Revision 1 - 2/15/2010 5:41 PM

# State-of-the-Art Reactor Consequence Analyses (SOARCA) Project

## Appendix B Surry Integrated Analysis

Figure 108: Schematic of the unmitigated ISLOCA piping layout.

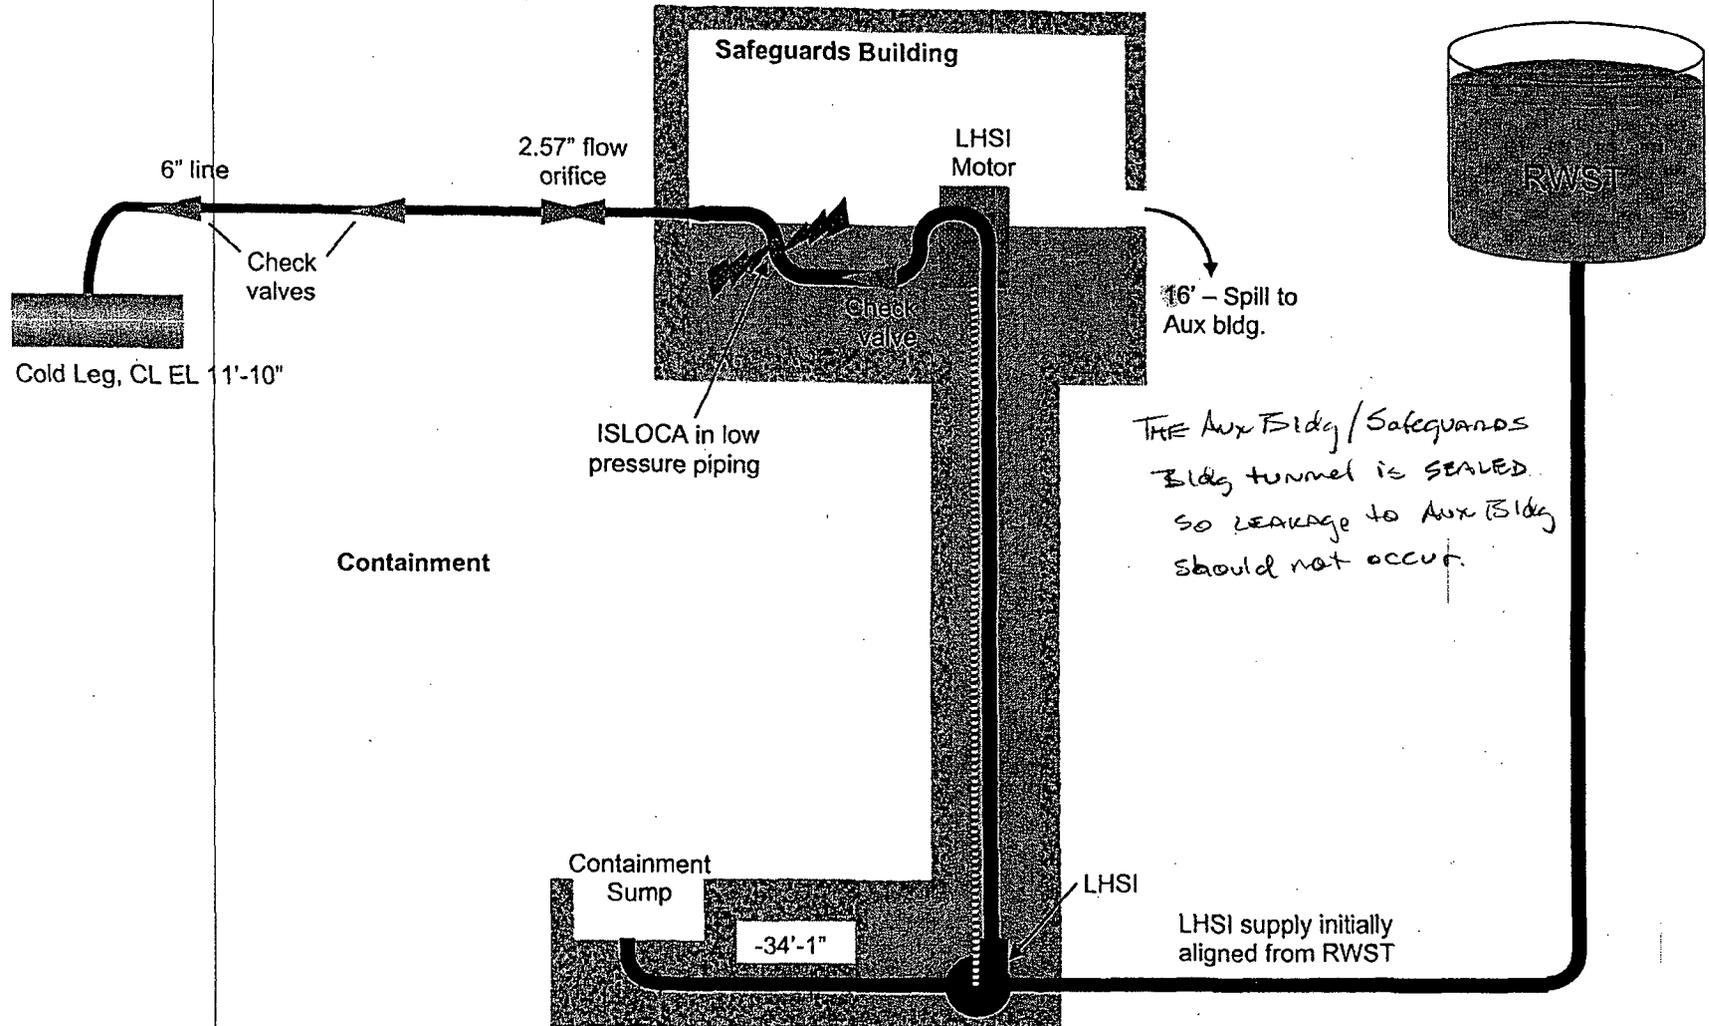
TURBINE TRIP  
DOES NOT TRIP  
FEEDWATER  
PUMPS.

SAME COMMENT.  
 TCVs DO NOT  
 TRIP FW  
 PUMPS.
